Addendum No. 2

Reference: Regional Training Institute – TASS Phase 2
Utah National Guard – Camp Williams, Utah
DFCM Project No. 11020480

ISSUE DATE:	1 April 2013
RESPONSE TO:	Contractor Requests for Information & DFCM Comments
PROJECT:	**RTI TASS Complex, Phase II** **Administration & Billets Buildings** 17800 South Academy Street Utah National Guard Camp Williams **DFCM'S PROJECT #:** 11020480 **NGB'S PROJECT #:** 490444 **ARCHITECT'S PROJECT #:** 11024
OWNER:	**Utah National Guard** 12953 South Minuteman Drive Draper, Utah 84020-1726
SUBJECT:	**VARIOUS CLARIFICATIONS**
ATTACHED:	**VOLUMES A.1 & A.2**

1 FA103 LEVEL 3 FIRE SYSTEMS PLAN
1/8" = 1'-0"

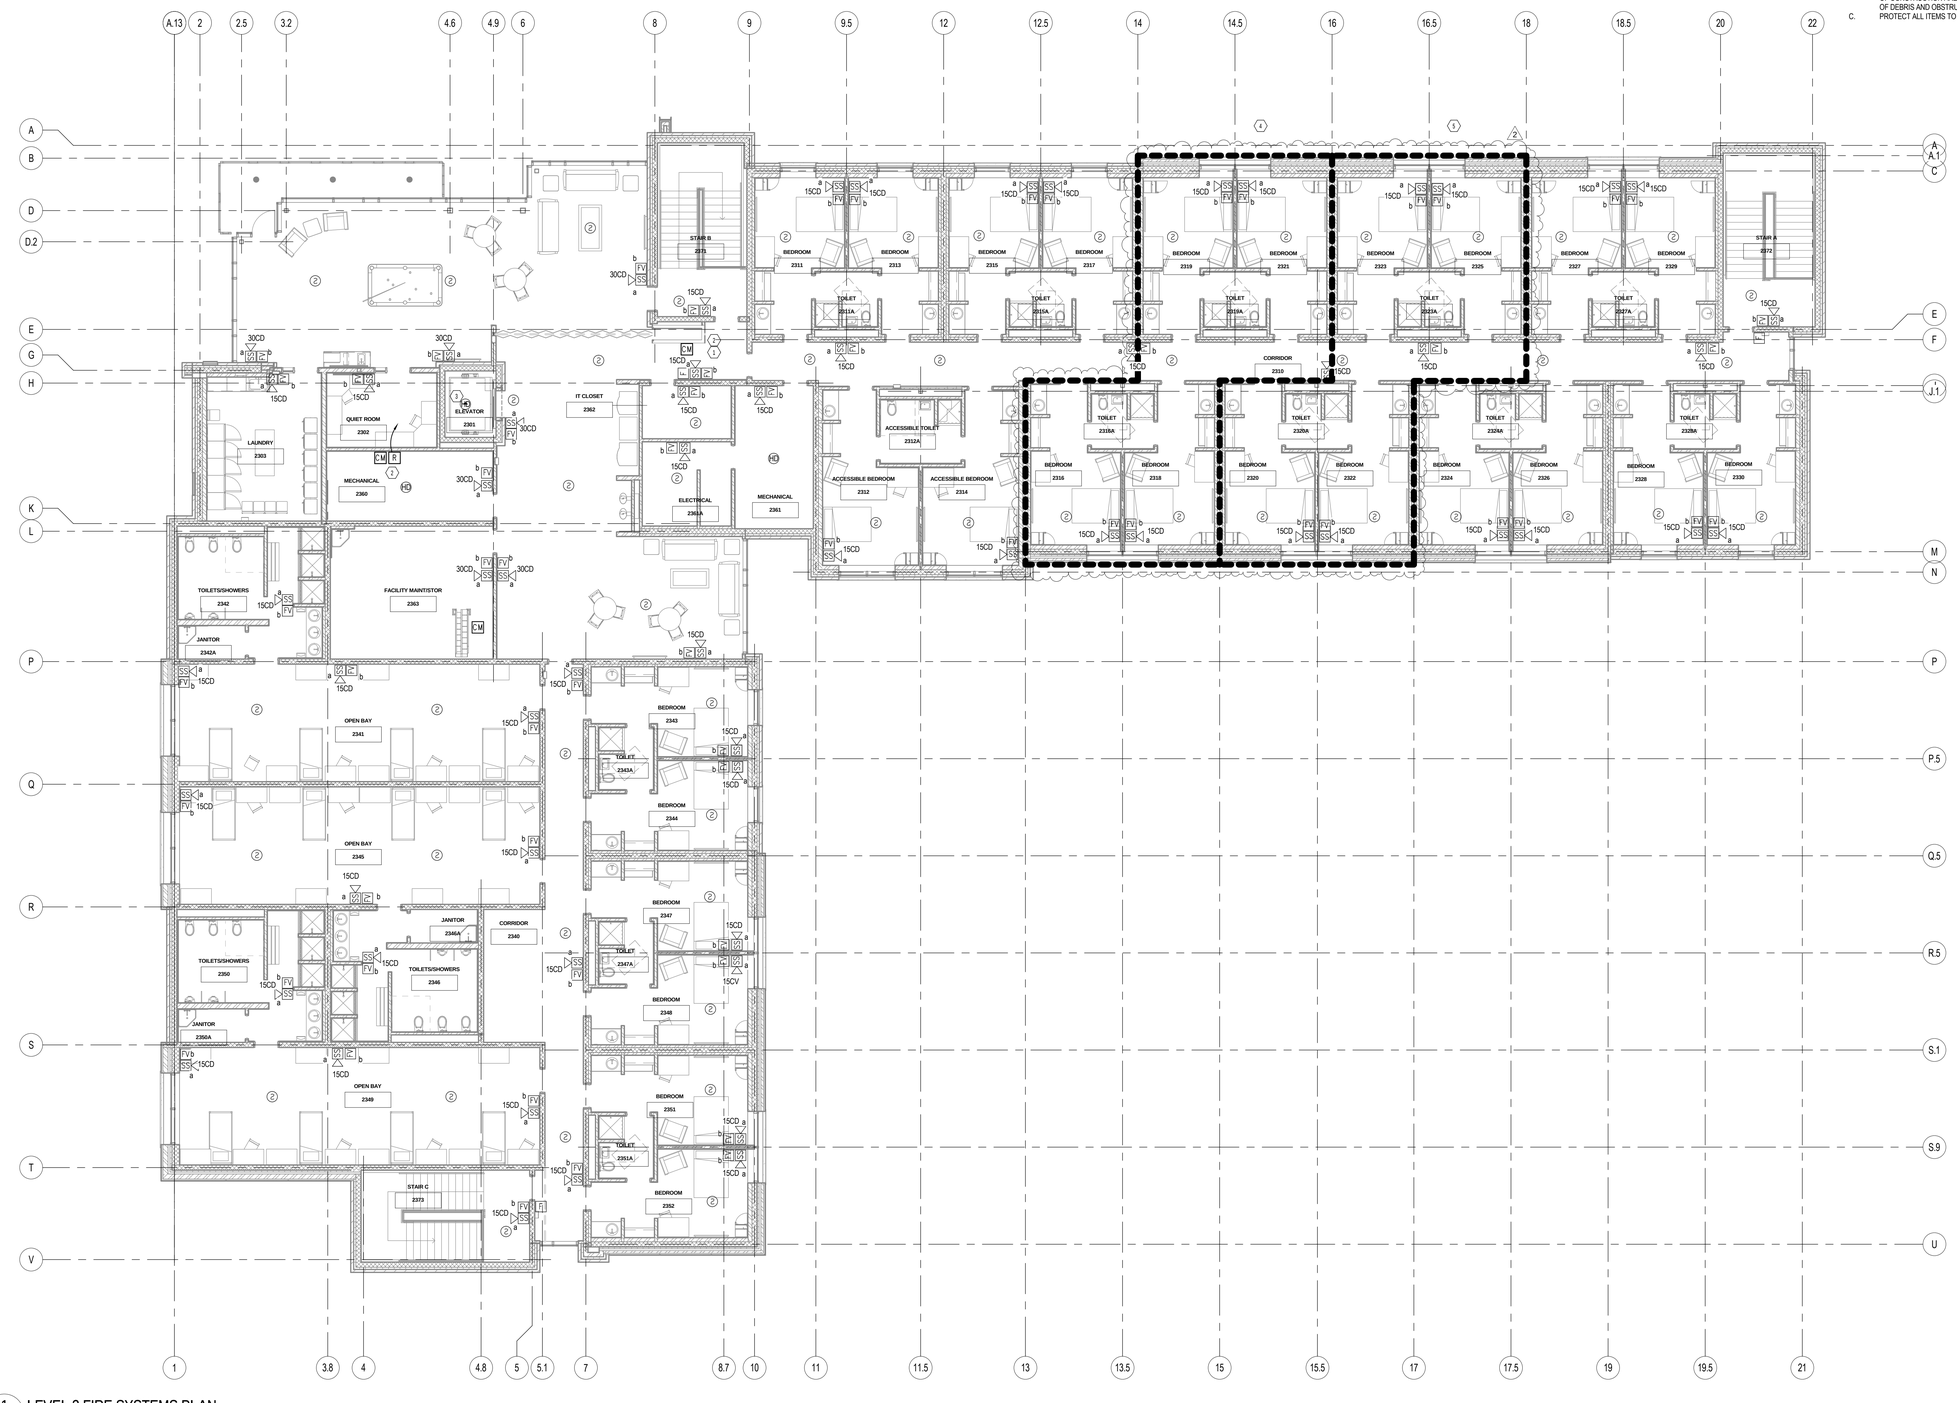
Item #	Sheet(s)	Amendment
B4.01	FX101, FX102, FX103	*See the attached Memorandum from Engineer, dated March 28, 2013*
B4.02	FA101, FA102, FA103	**REVISE** sheets to indicate areas associated with Add/Alt #2 and #3, as shown in sheets provided.

1 EL101 LEVEL 1 LIGHTING PLAN
1/8" = 1'-0"

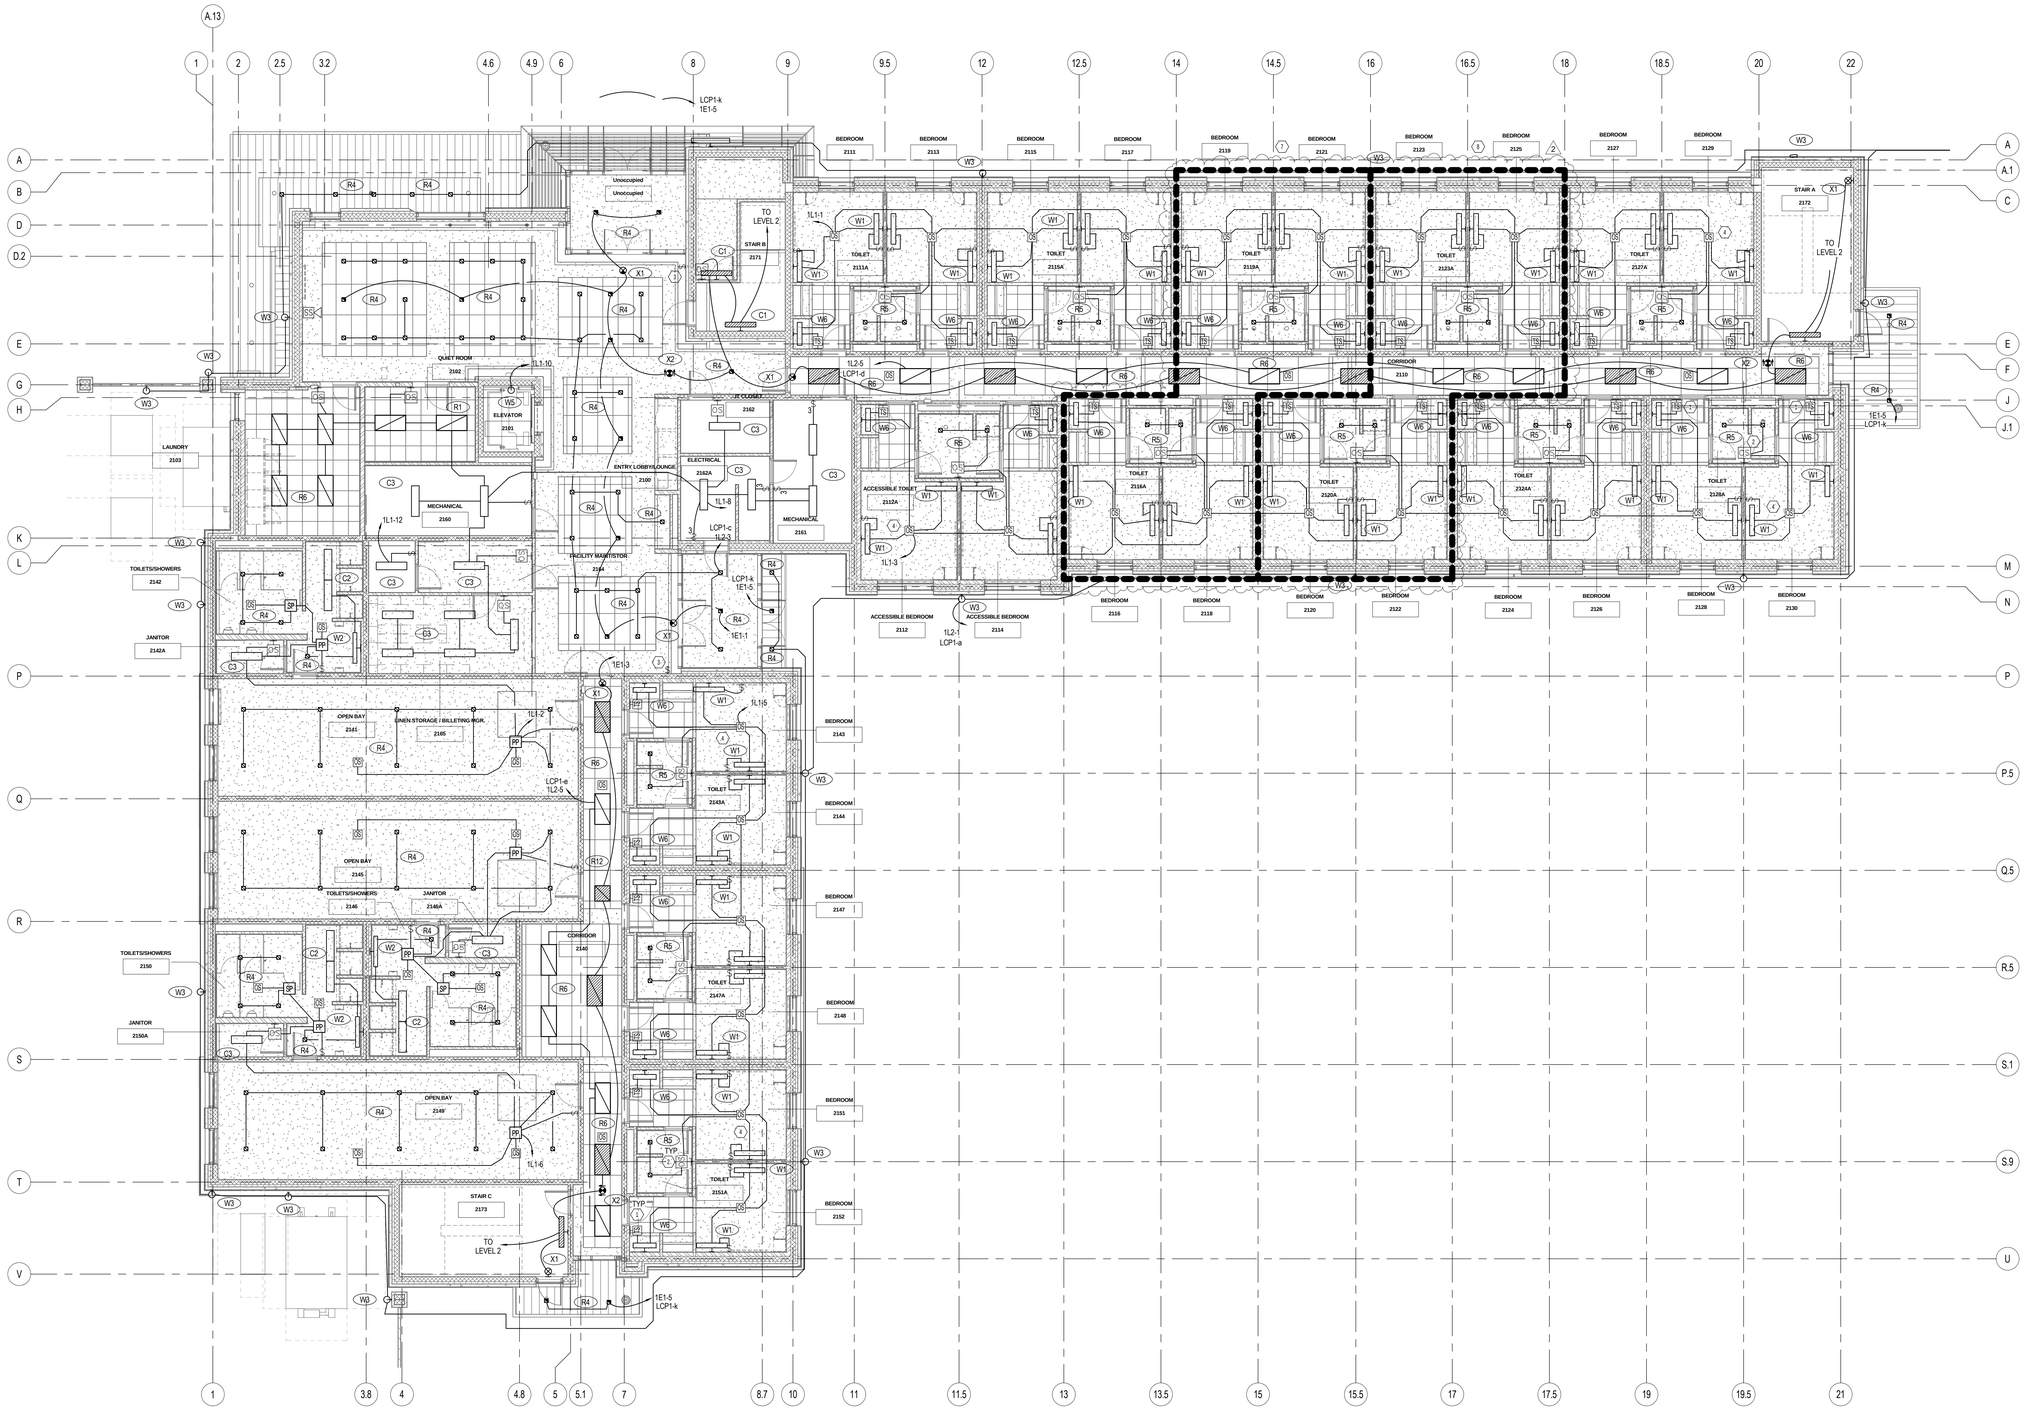
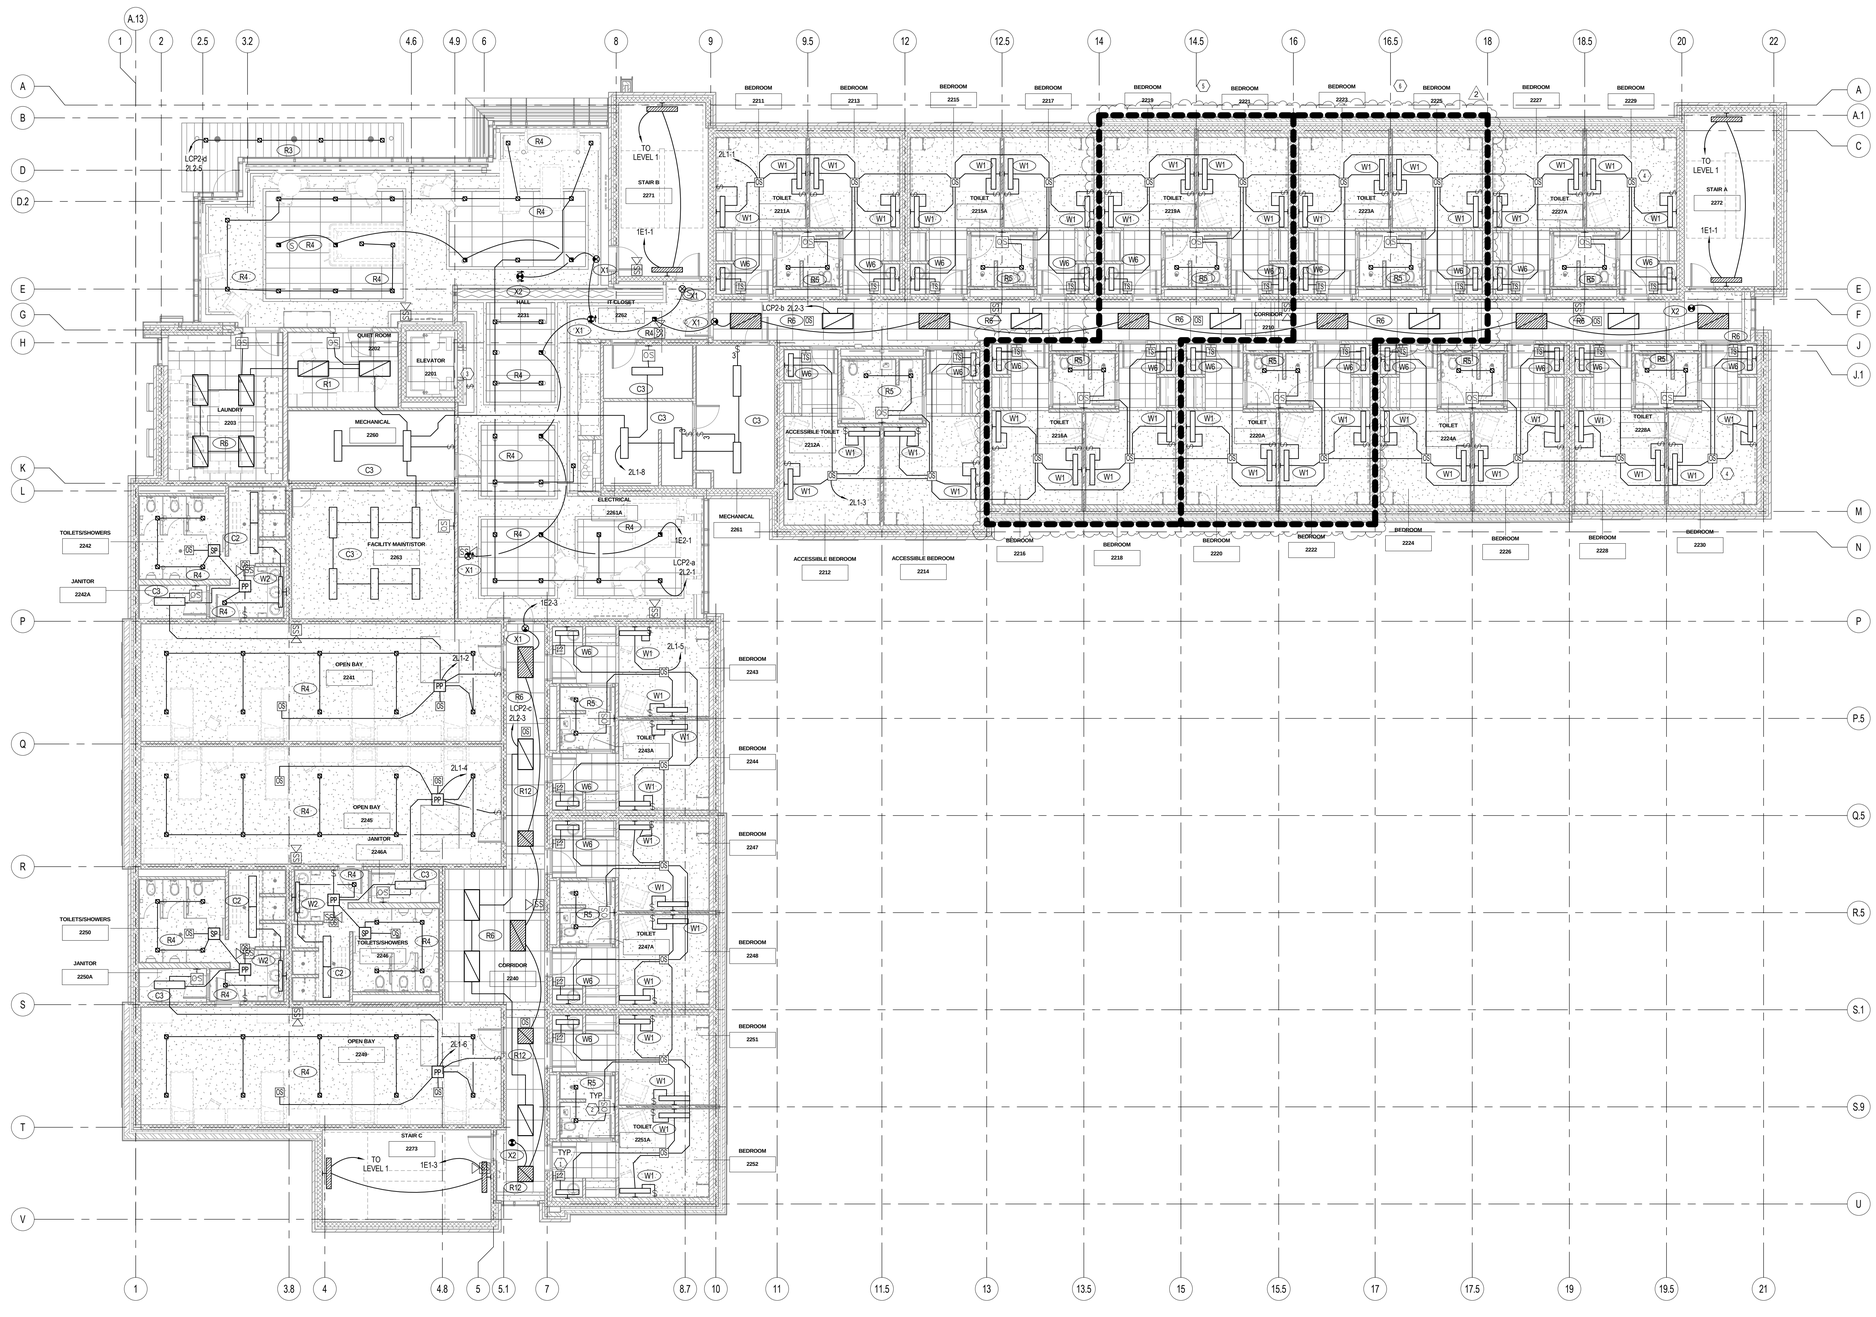
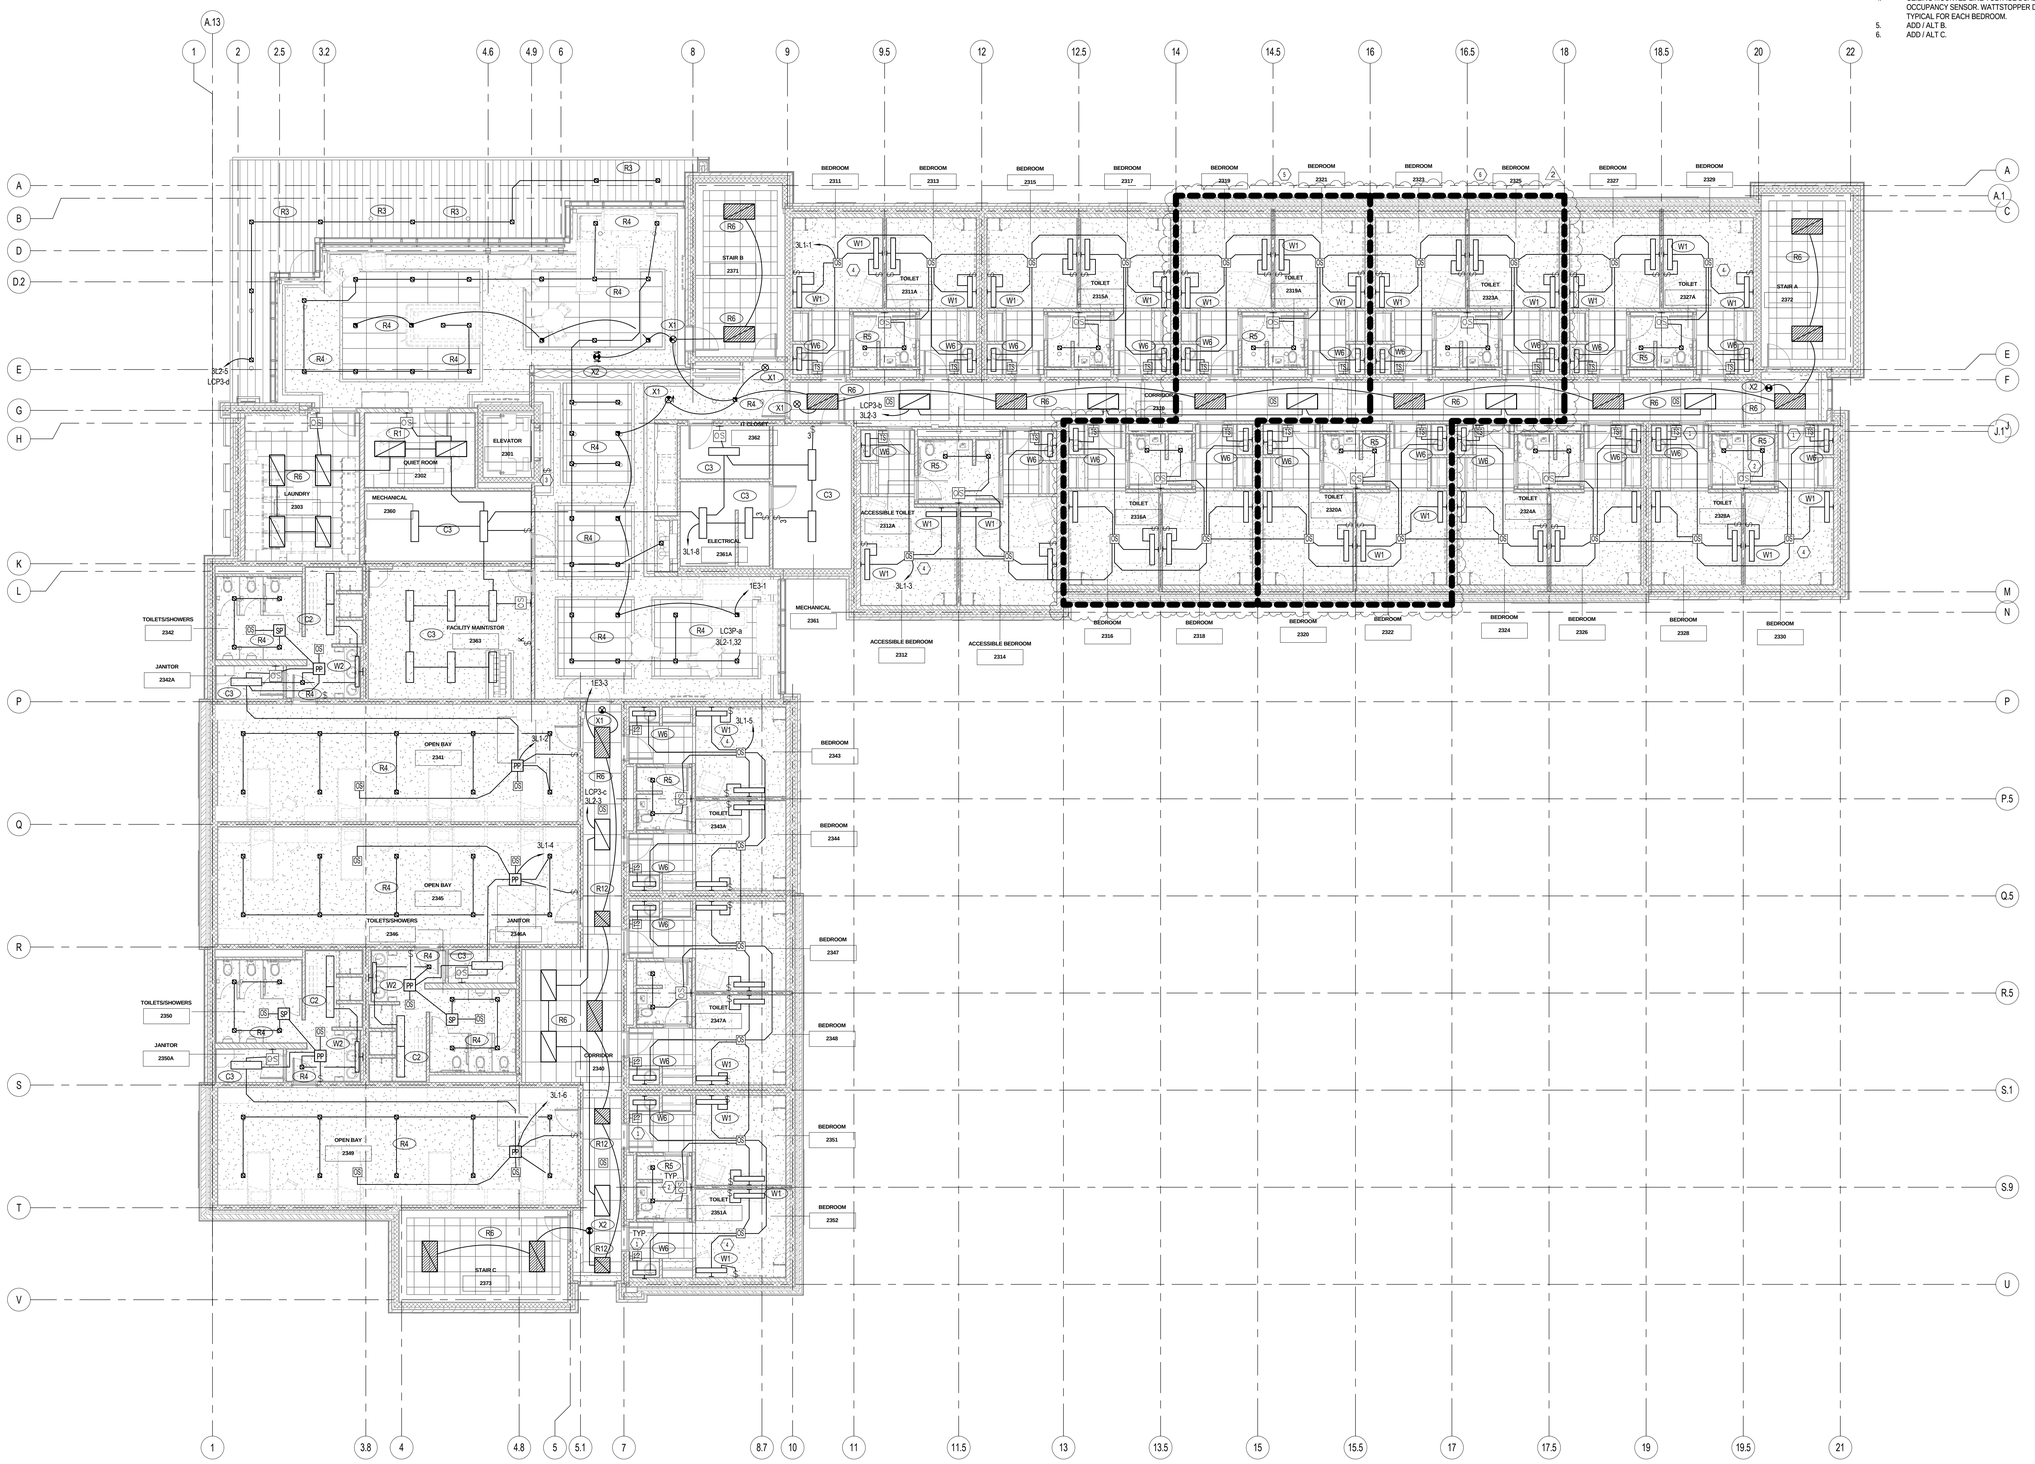
Item #	Sheet(s)	Amendment
B7.01	EL101, EL102, EL103, EP101, EP102, EP103	**REVISE** sheets to indicate areas associated with Add/Alt #2 and #3, as shown in sheets provided.
B7.02	EP601	**DELETE** keyed note #1.
